April 1, 2024

PROJECT NAME: MAJOR SITE PLAN FOR HWY 200 STORAGE FACILITY

PROJECT NUMBER: 2023110100

APPLICATION: MAJOR SITE PLAN #30898

Section & Title of Code: 6.8.6 - Buffer (North Buffer)

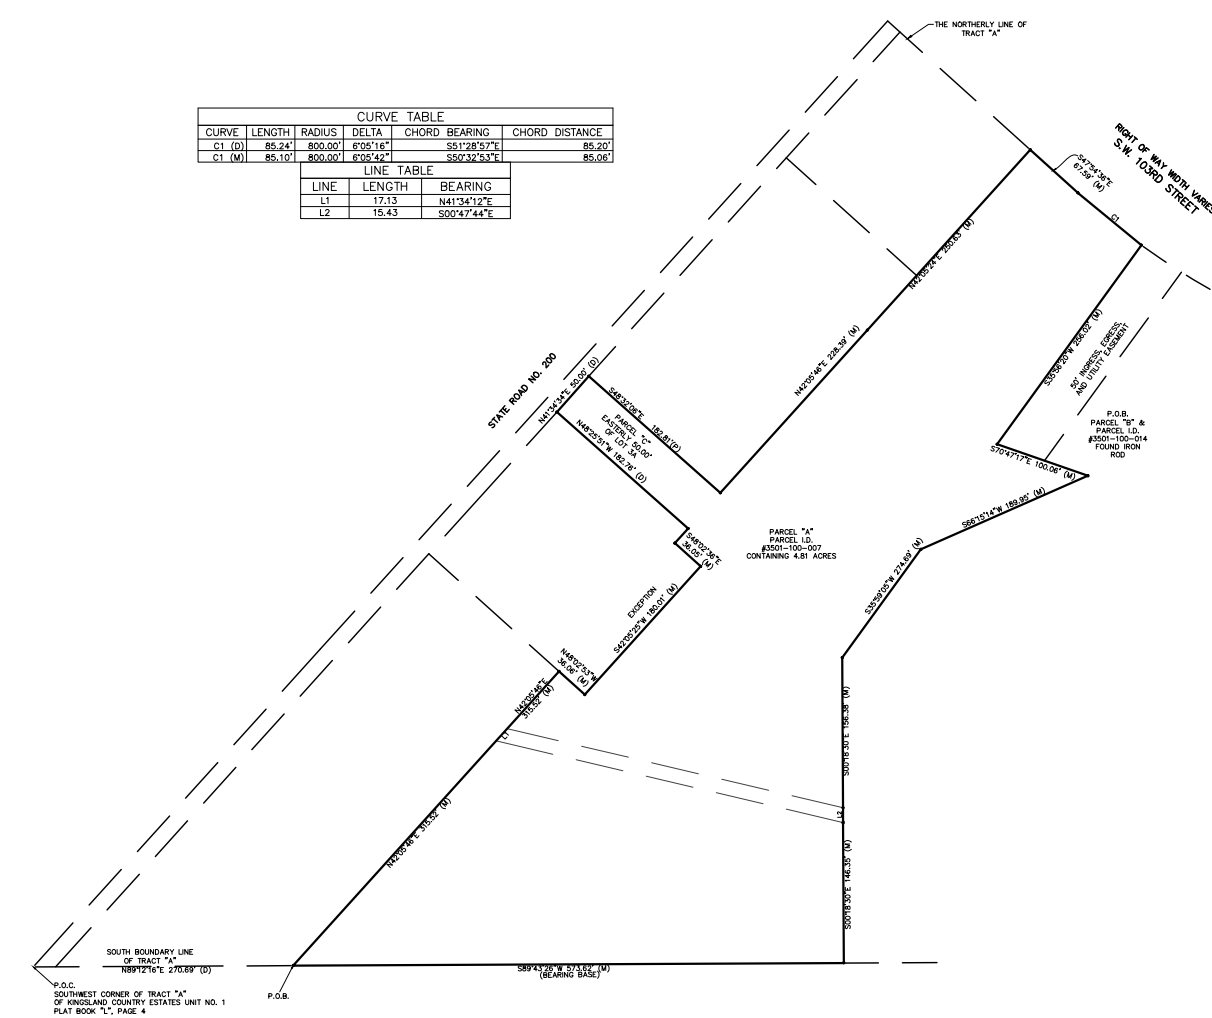
Reason/Justification for Waiver Request: Existing power lines prevent trees in this area. Request only Understory trees be used.

UTILITY PLAN
MAJOR SITE PLAN
HWY 200 STORAGE FACILITY
MARION COUNTY, FLORIDA

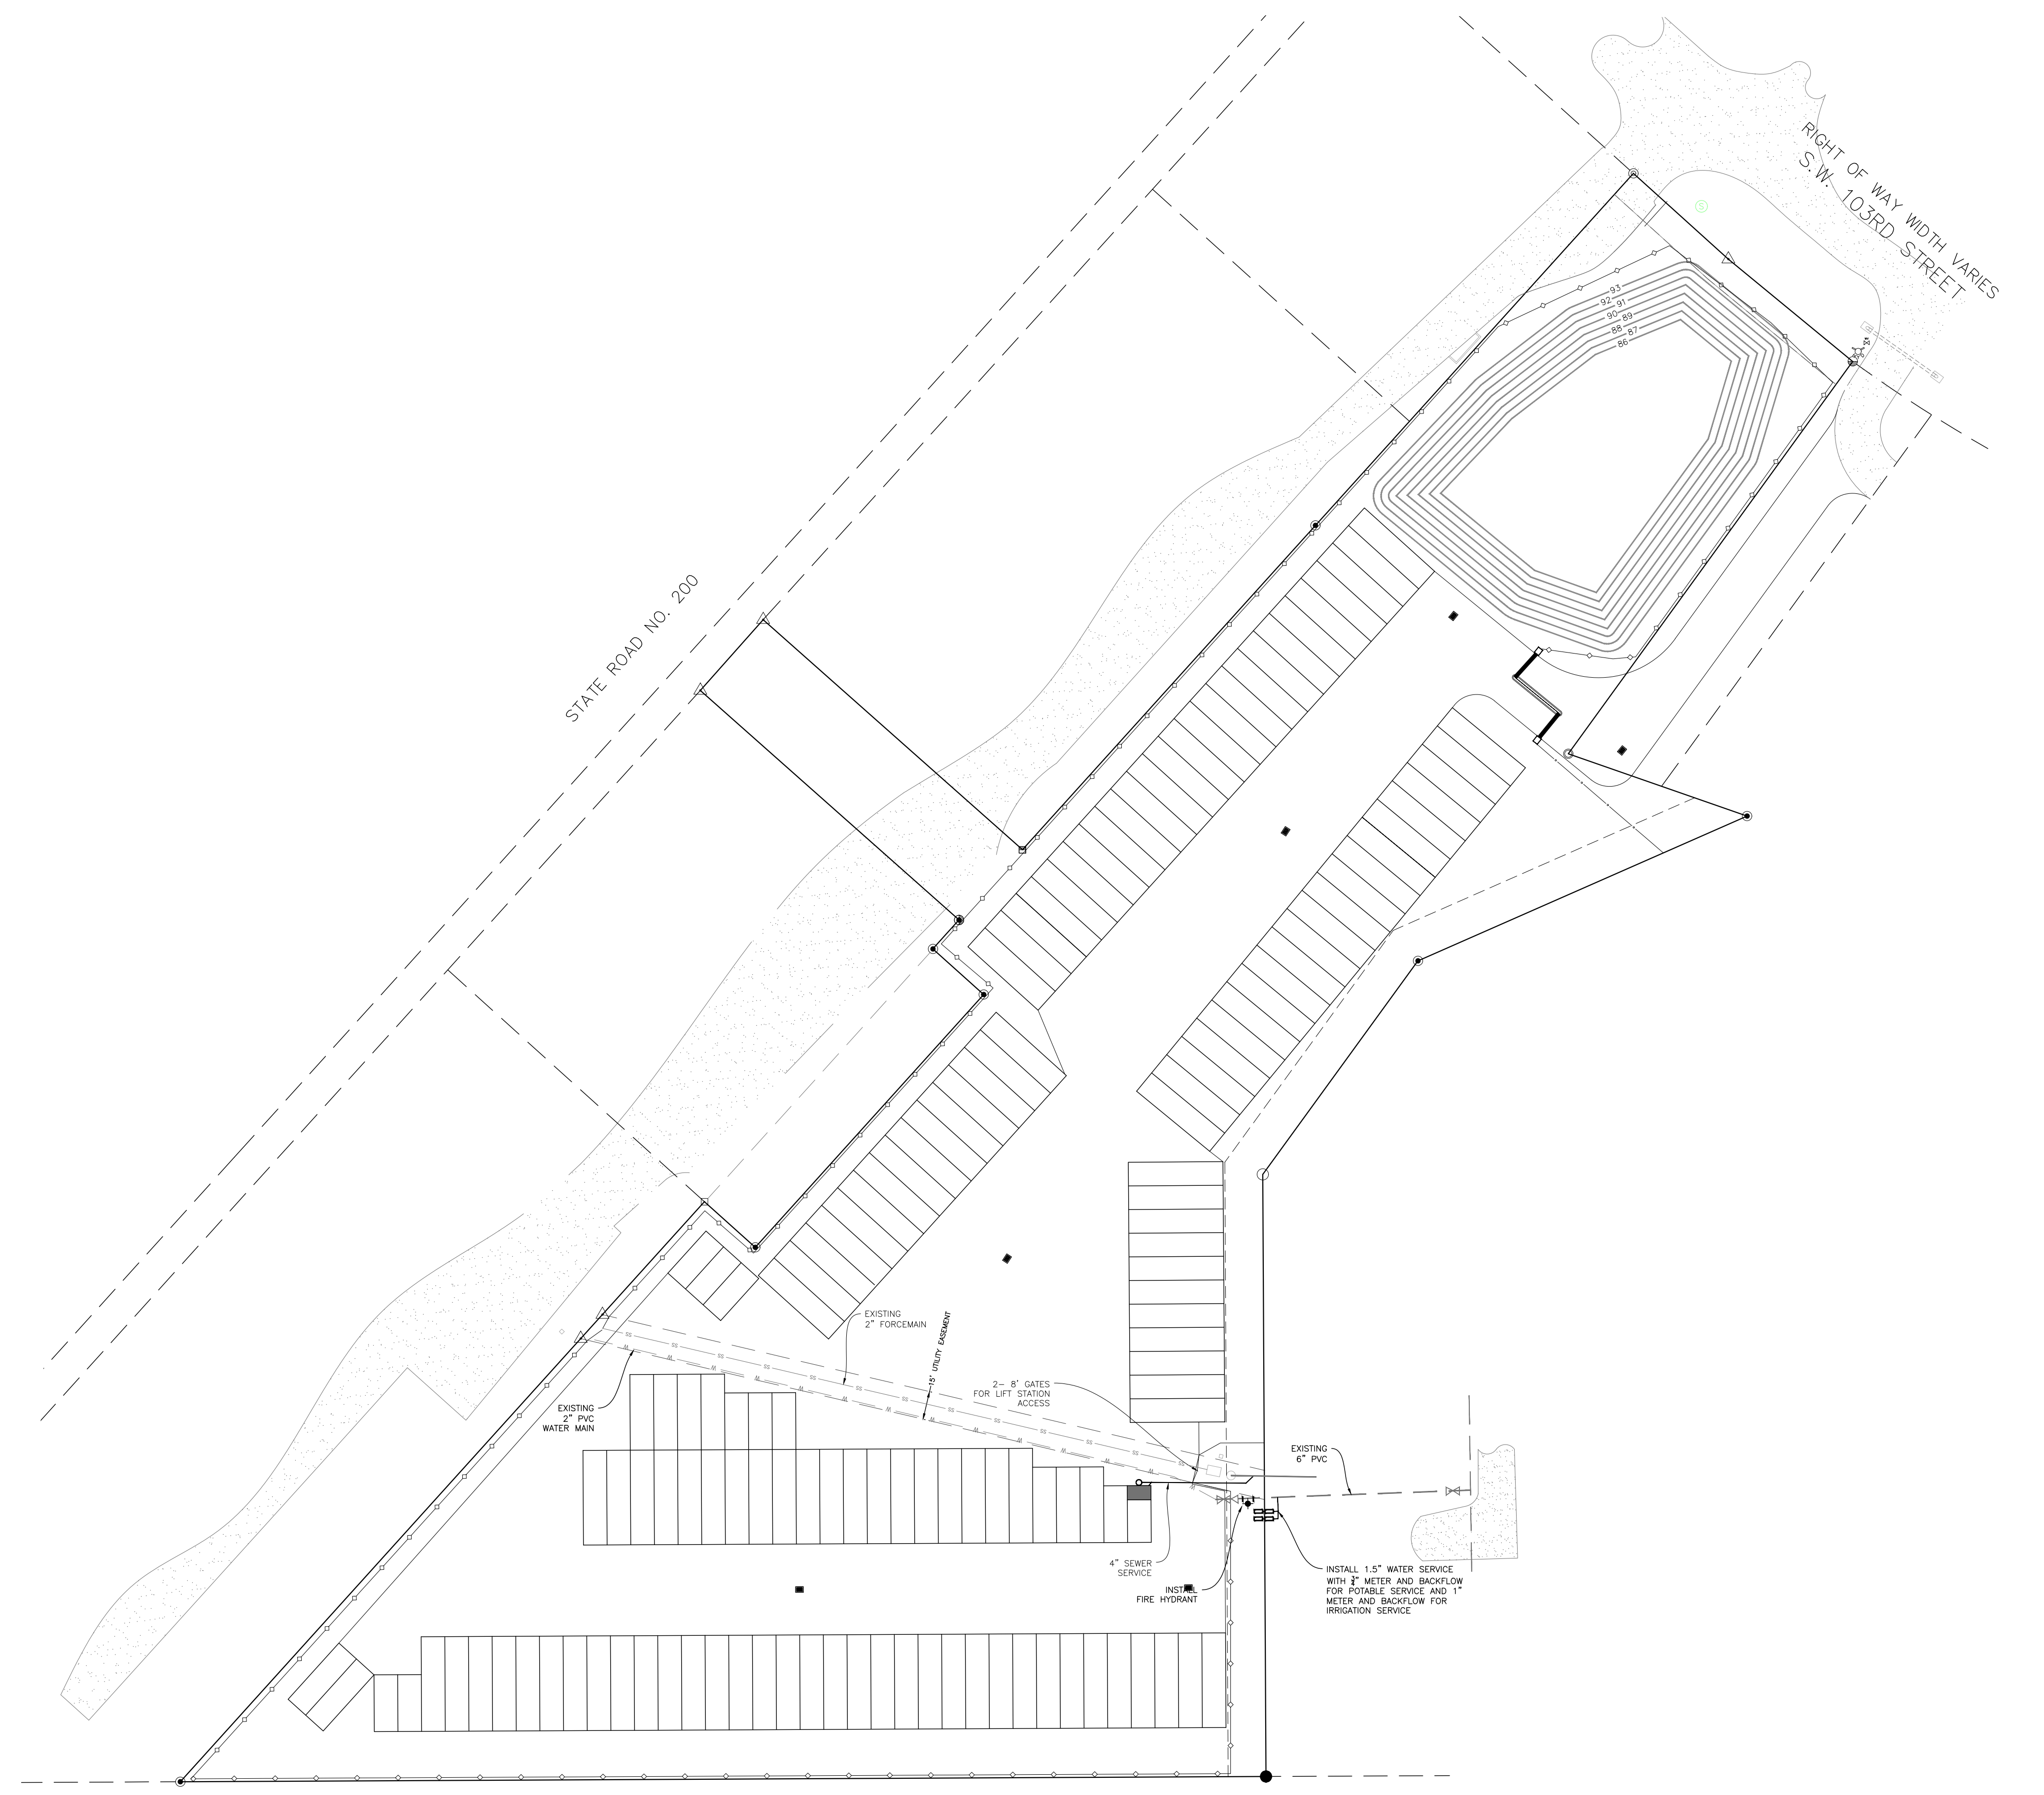
- 9 DEPARTMENT: UTIL - MARION COUNTY UTILITIES
REVIEW ITEM: 6.14.9.B - Transfer of Facilities to Marion County Utilities - PLAN NOTE:
STATUS OF REVIEW: INFO
REMARKS: any assets to be conveyed to MCU post-DEP clearance shall be identified on the plan - sheet 04

- 36 DEPARTMENT: UTIL - MARION COUNTY UTILITIES
REVIEW ITEM: 6.14.5.A(1) - Submittal Requirements - Existing on-site & off-site mains and service connections
STATUS OF REVIEW: NO
REMARKS: see changemarks Sheet 04 - identify comments & noted changes in response letter to correspond with numbered items

- 38 DEPARTMENT: UTIL - MARION COUNTY UTILITIES
REVIEW ITEM: 6.14.7 - Construction Inspection - PLAN NOTE:
STATUS OF REVIEW: NO
REMARKS: note on sheet 04 ""MCU personnel are to inspect any work performed on or around existing MCU infrastructure. A pre-construction meeting is required to be held a minimum of 48 hours prior to start of any construction. If the pre-construction meeting is not completed, any work may be halted. To schedule, contact MCU's Construction Officer at 352-307-6163."

LANDSCAPE PLAN
MAJOR SITE PLAN
HWY 200 STORAGE FACILITY
MARION COUNTY, FLORIDA

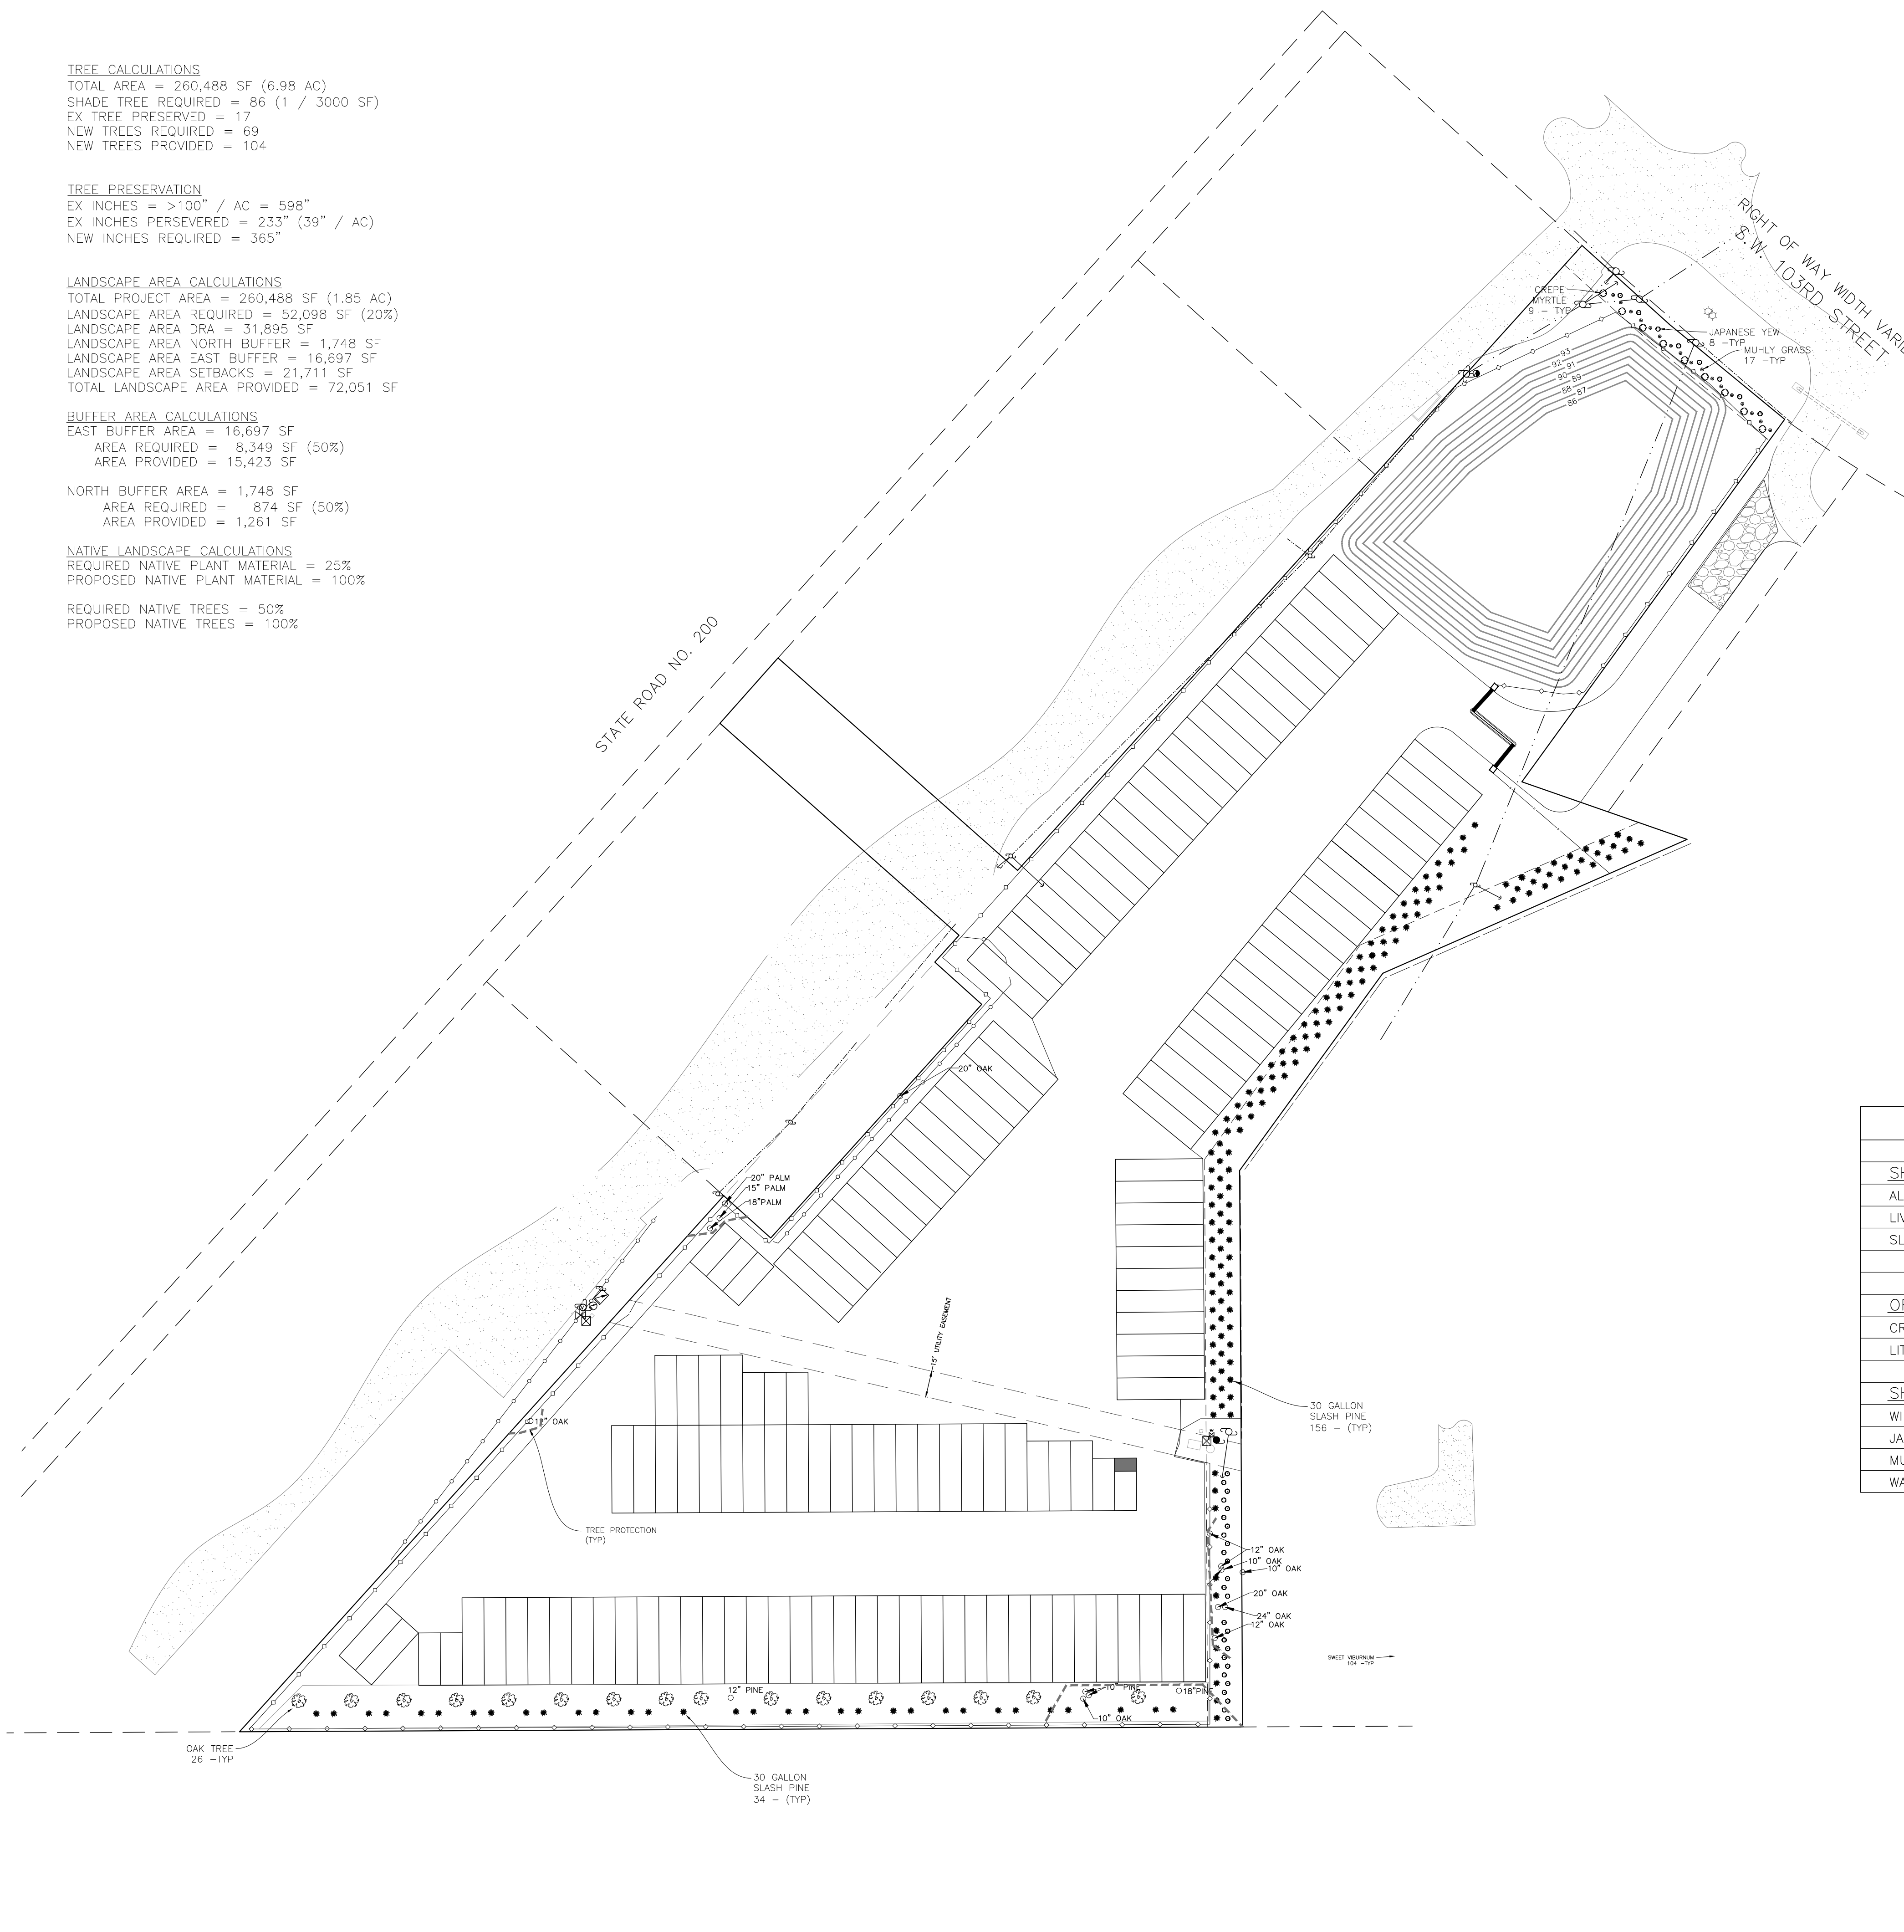
- 61 DEPARTMENT: LSCAPE - LANDSCAPE DESIGN AND IRRIGATION
REVIEW ITEM: 6.8.3 - Landscape design standards
STATUS OF REVIEW: NO
REMARKS: Pines are not acceptable in east buffer, too close to adjacent homes

- 62 DEPARTMENT: LSCAPE - LANDSCAPE DESIGN AND IRRIGATION
REVIEW ITEM: 6.8.6 - Buffers
STATUS OF REVIEW: NO
REMARKS: 1. Label buffer types 2. Schedule to include width, height and spacing requirements. 3. Taxus Cuspidata is not widely available, suggest Podocarpus macrophyllus 'Pringles' 4. The shrubs and groundcovers in the north buffer do not meet the 50% requirement for square footage 5. East buffer is a type B, waiver for wall required. 6. Show shrubs and groundcovers for east buffer 7. Label plant symbols
